## TEXAS COMMISSION ON ENVIRONMENTAL QUALITY

Re: Edwards Aquifer, Comal County  
NAME OF PROJECT: McKenna Health Care M.O.B.; Located at the northeast corner of FM 311 and FM 3159; New Braunfels, Texas  
TYPE OF PLAN: Request for Approval of a Contributing Zone Plan (CZP); 30 Texas Administrative Code (TAC) Chapter 213 Subchapter B Edwards Aquifer  
Edwards Aquifer Protection Program File No. 2460.00  
Regulated Entity No. RN104860382  
Investigation No. 454089

# MCKENNA HEALTH CARE Contributing Zone Plan Phase 1 NEW BRAUNFELS, TEXAS, M.O.B.

SCALE: AS SHOWN DATE: 02-03-06  
DESIGNED BY: A. DODSON  
DRAWN BY: J. MCMAHON  
CHECKED BY: A. DODSON  
APPROVED BY: A. DODSON  
PROJECT NO: 120221-160-10157-400

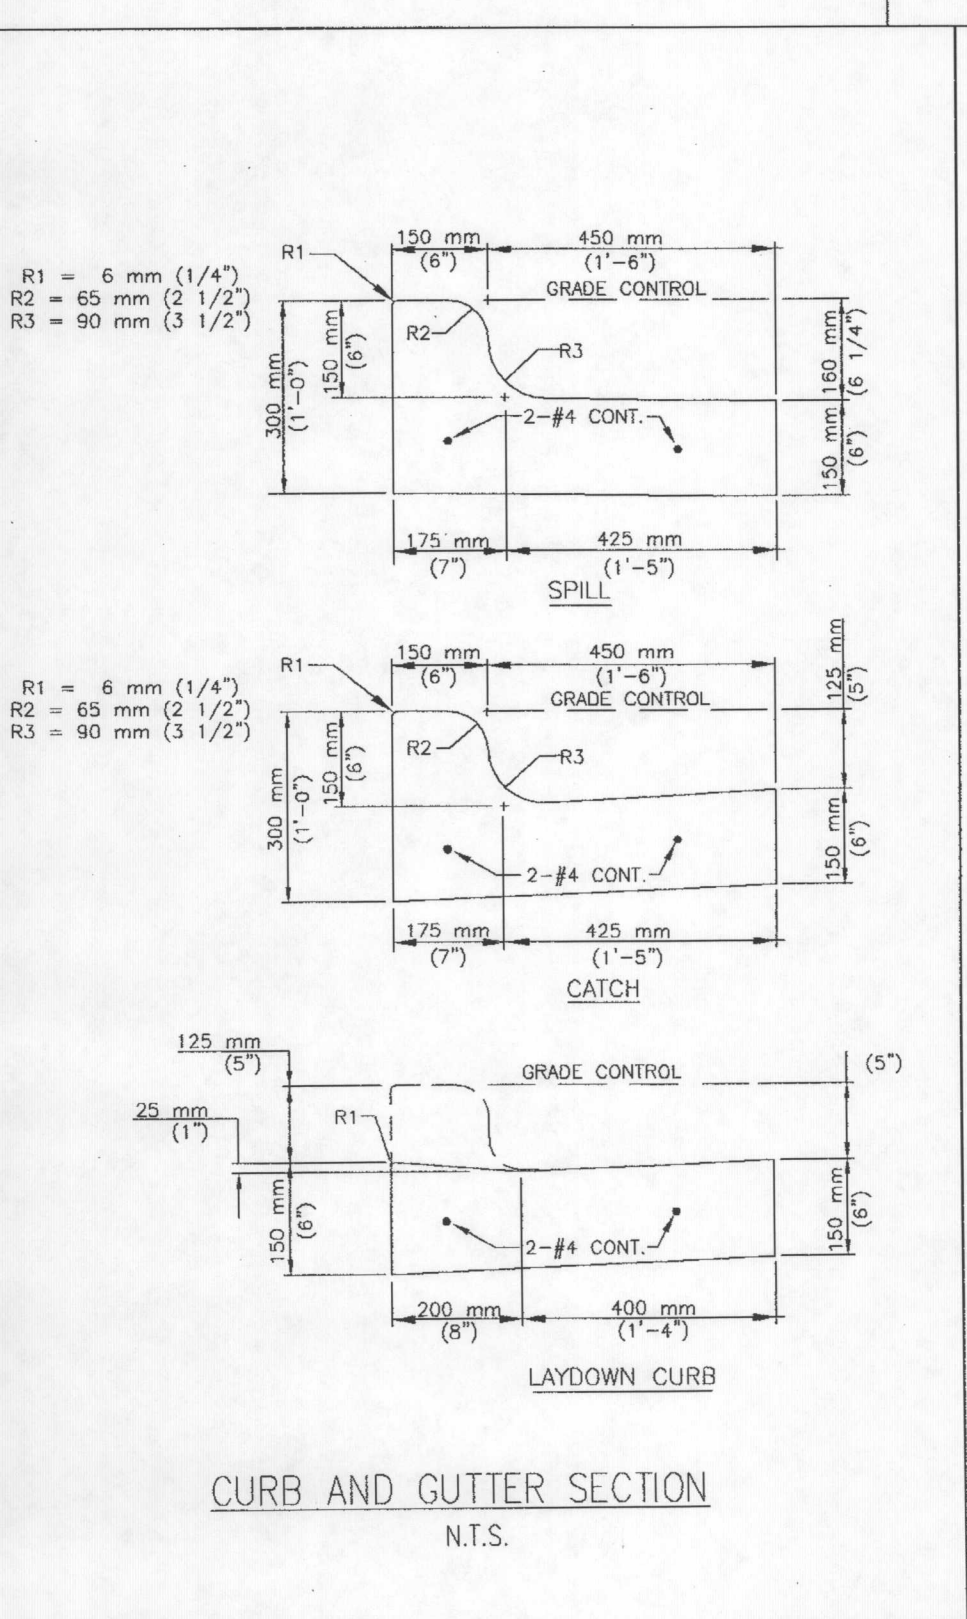
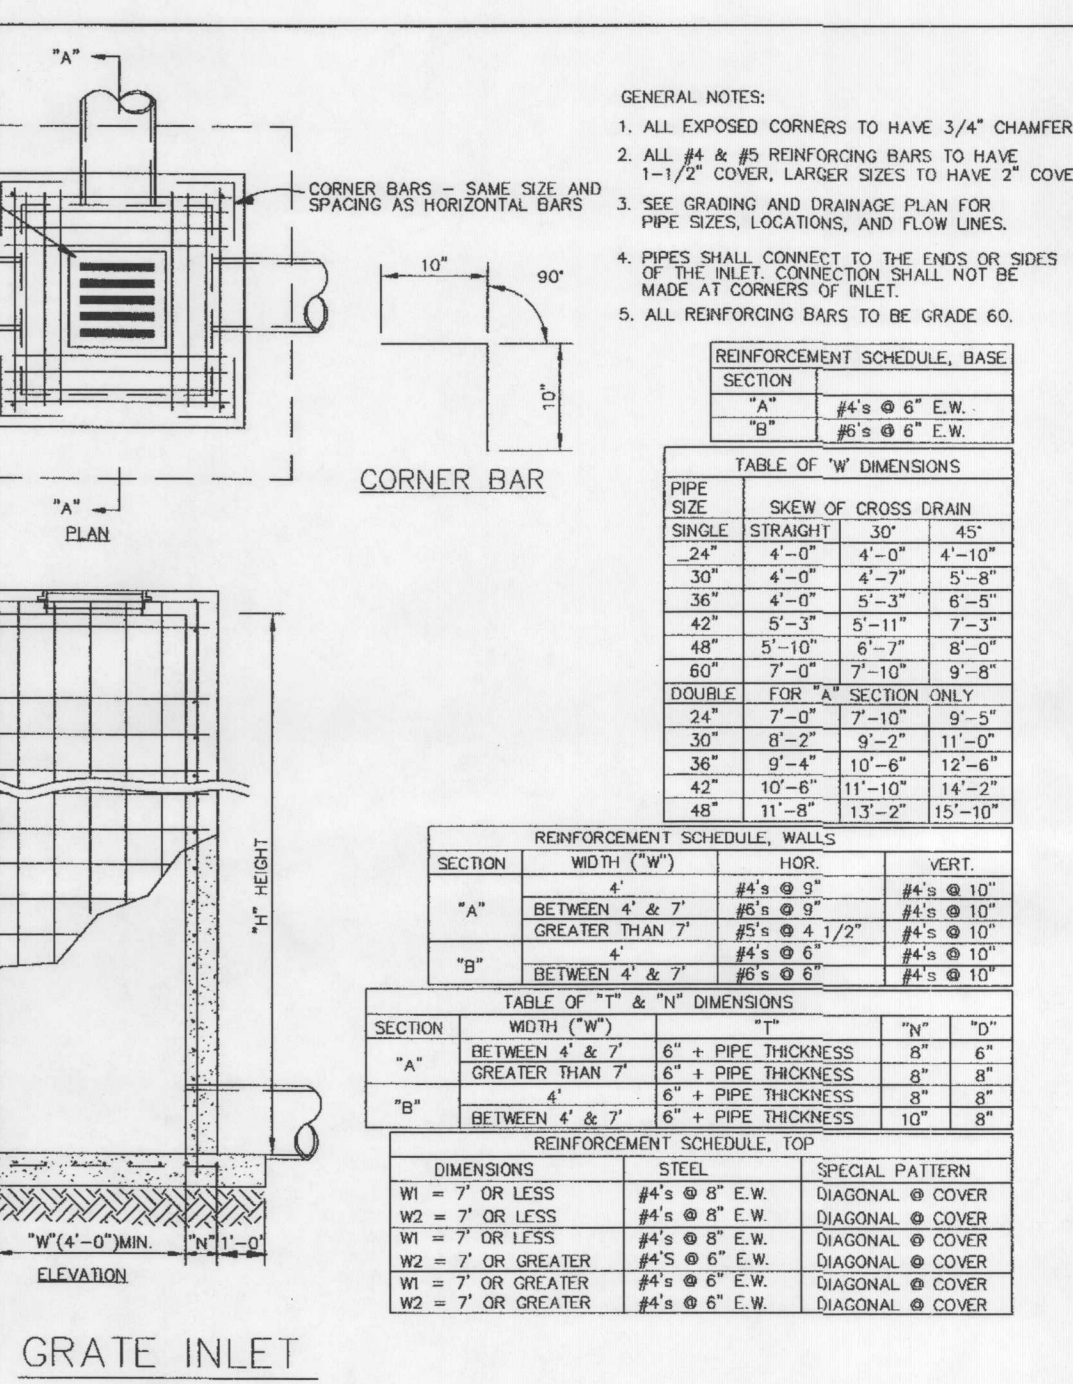
1. Detailed answers are provided for each question..
2. The pond has a design volume of 26,771 cubic feet which is in access of the required volume of 8,681 cubic feet per TCEQ spreadsheet. The pond will treat 1790.62 lbs of TSS per year. The sand filter area is 2,856 square feet in area. All these items are shown on sheet 7 of the plan set.

4. The following items are shown on sheet 7 of the plan set.
  - a. Flow line information is shown for underdrain piping at 1%.
  - b. Call out for maximum separation of 10' center to center is shown on sheet 7.

- c. Call out for screw on caps is labeled.
  - d. No basin liner is required this is a CZP plan not WPAP.
  - e. No basin liner is required this is a CZP plan not WPAP.

- f. Control access fence and gate are shown.
  - g. Access ramps to sedimentation and filtration basins are shown.
  - h. Staging area is shown.
  - i. Depth of water is 4' as indicated in spread sheet on sheet 7. WQ Elevation is 1274' and bottom of sedimentation pond is 1270'.

MCKENNA HEALTH CARE  
NEW BRAUNFELS, TEXAS, M.O.B.  
GRADING PLAN - PHASE I

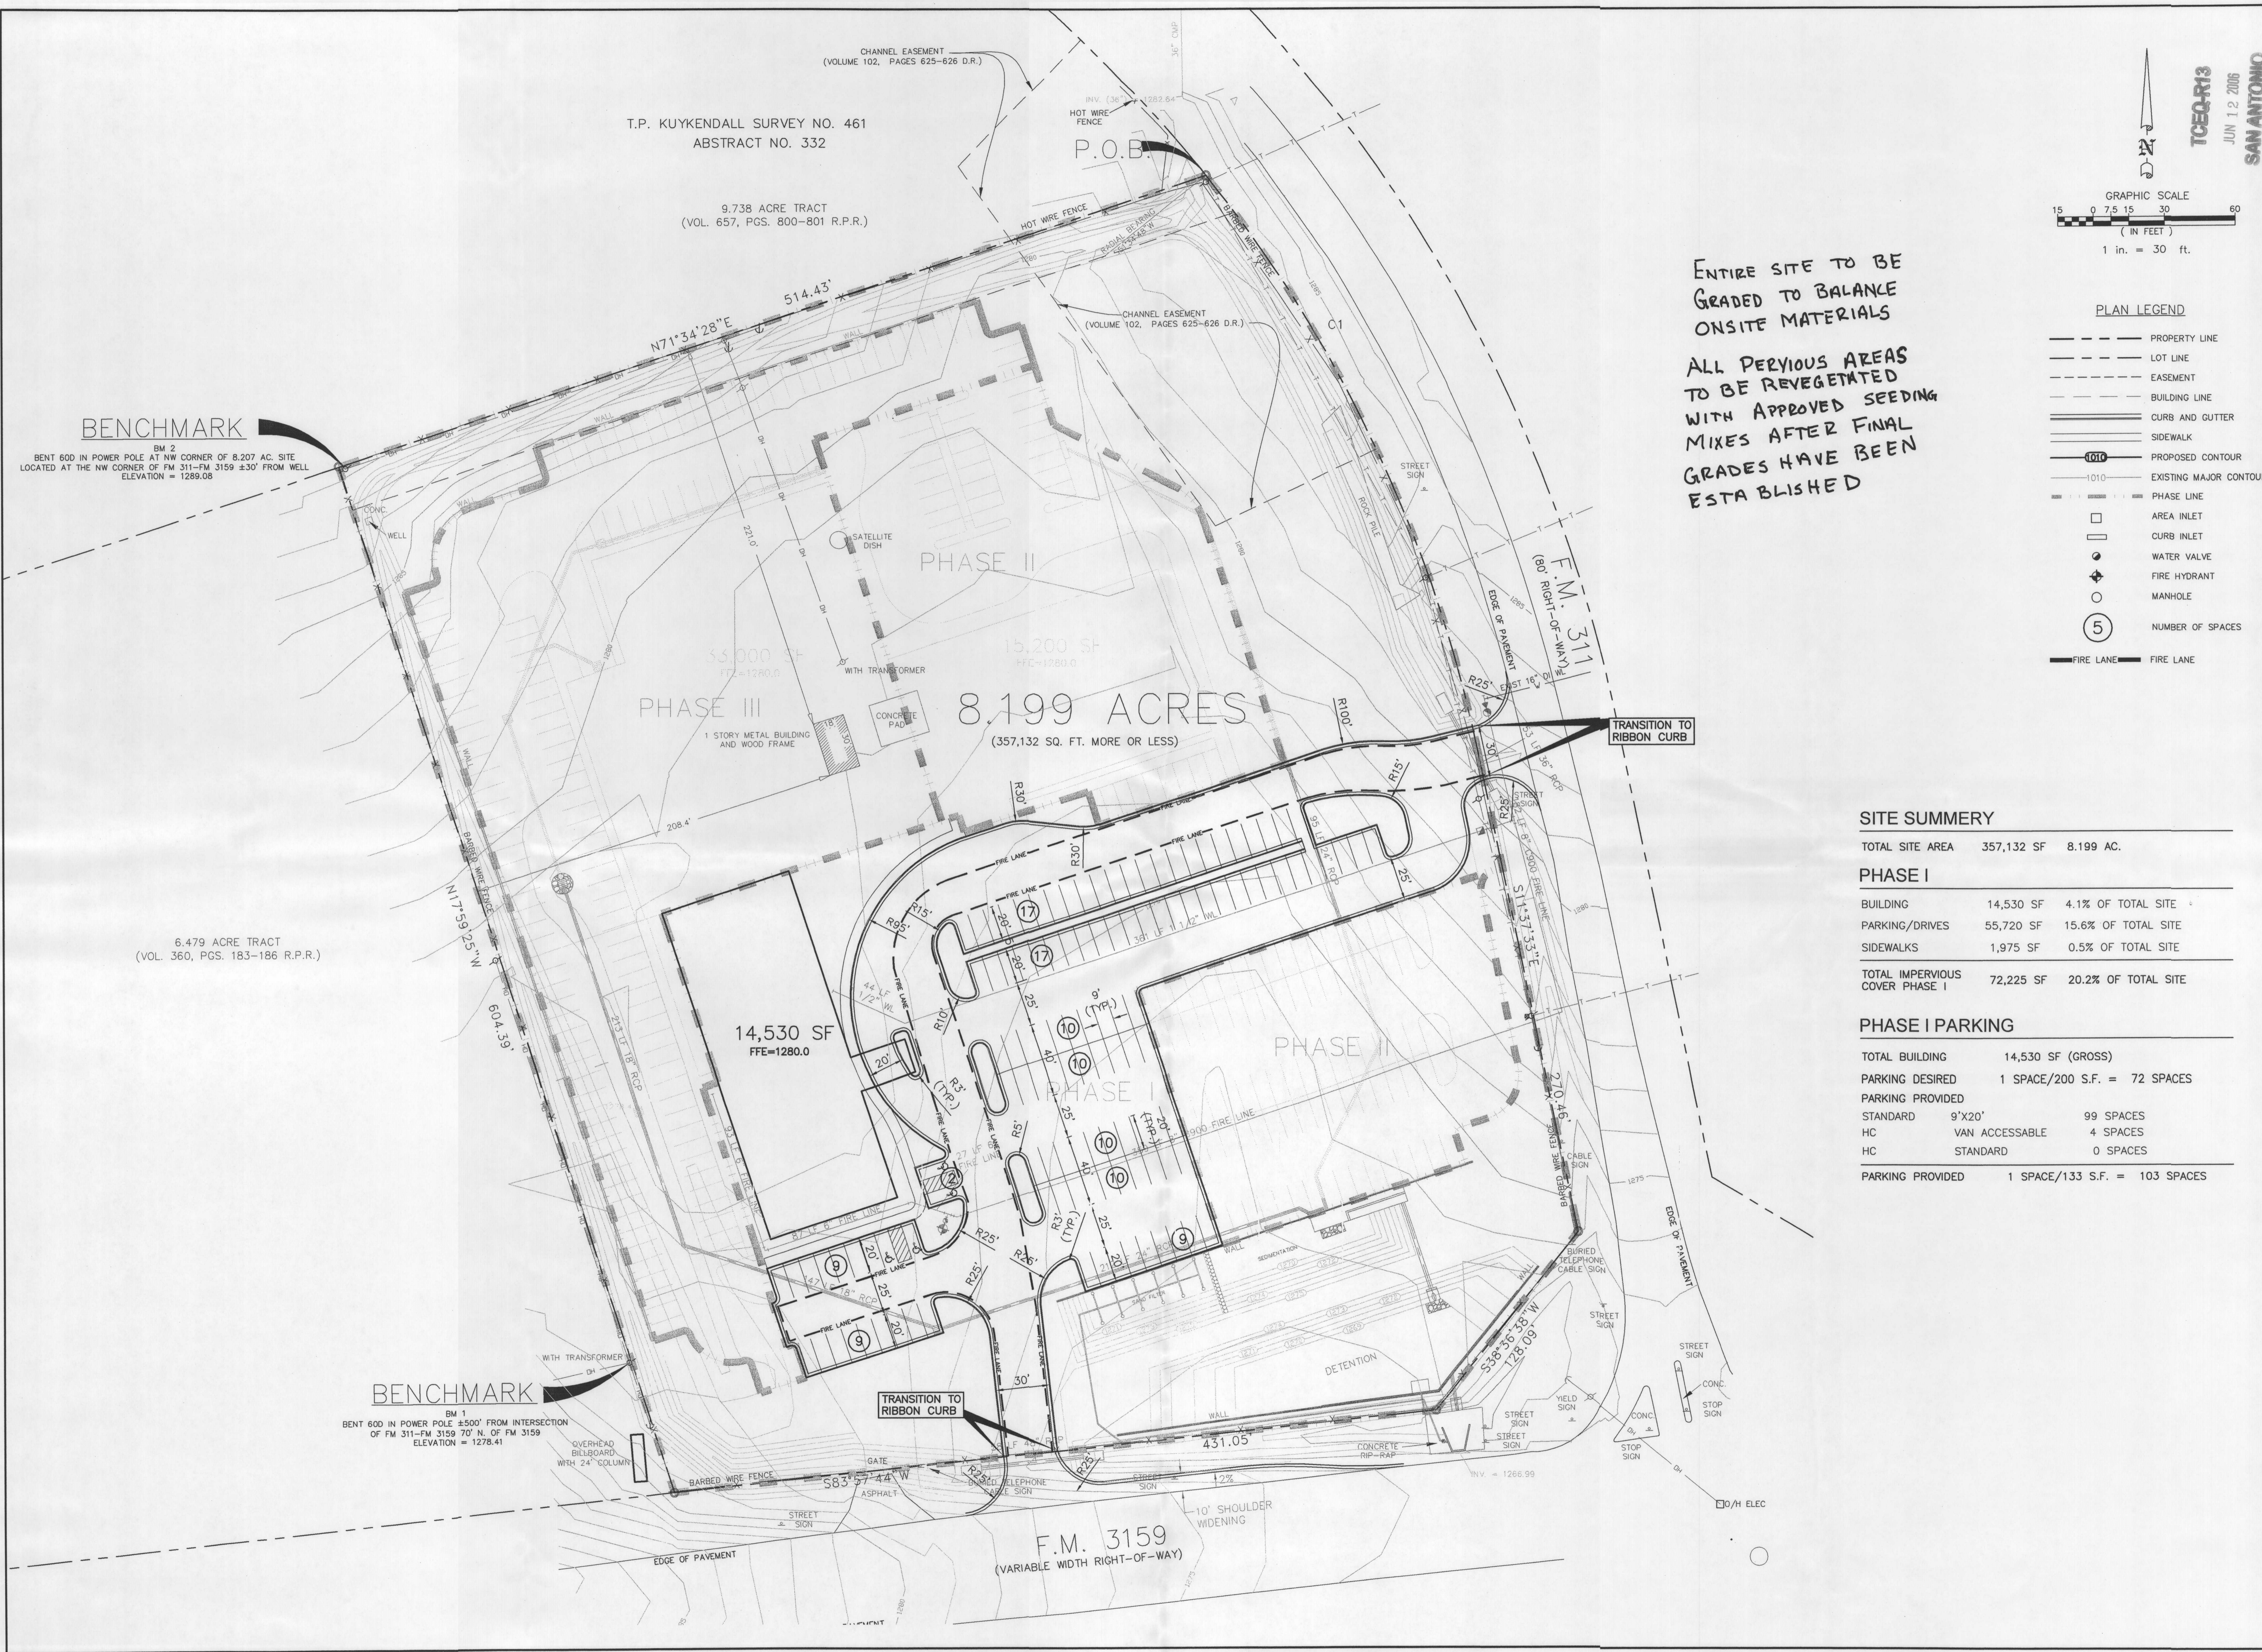
3. Sheet 5 shows flow path and areas that drain to pond and splitter box. All flows are overland to the splitter except the west side which is conveyed in storm pipe as shown..

NOTE:  
ALL DRAINAGE IS OVERLAND TO POND EXCEPT WEST SIDE. WEST SIDE IS PIPED TO SPLITTER AS SHOWN.
